Peer Review File

Decision Support and Guidance for Applying Hydraulic Modeling to Beaver Dam Analog Stream Restoration Projects

Round 1 Responses

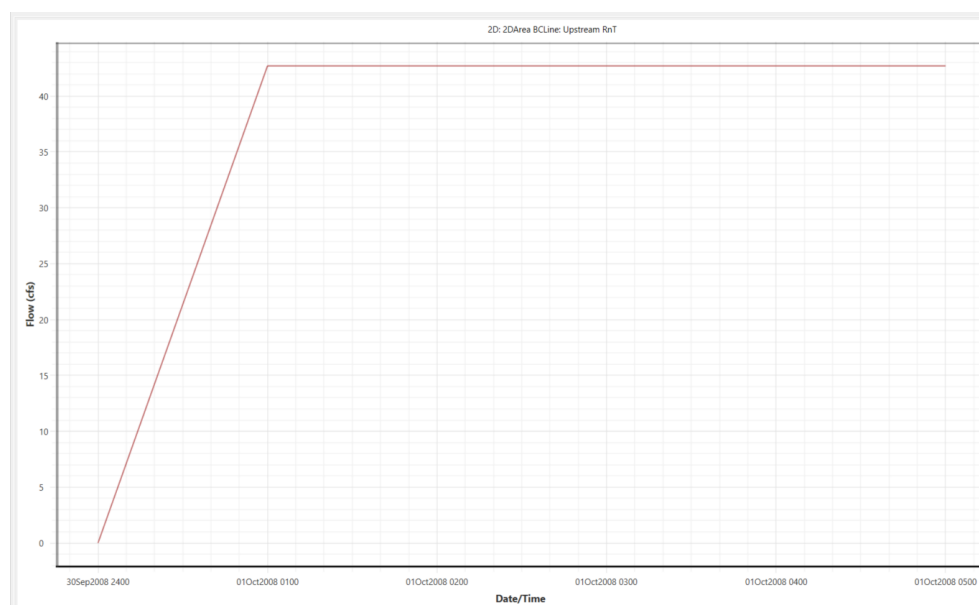
L252 What does "1-hour step up" mean? Please show the hydrograph/plot it. *The "1-hour step up" refers to the method used to bring flow from 0 cfs to the peak discharge Q listed in Table 3. Flow increased linearly over a one-hour period until the peak Q was reached. A hydrograph of this ramp-up has been included in this response document; however, because the manuscript is already near the journal limit, we believe this plot does not need to be included in the main text. Line 320-322.*
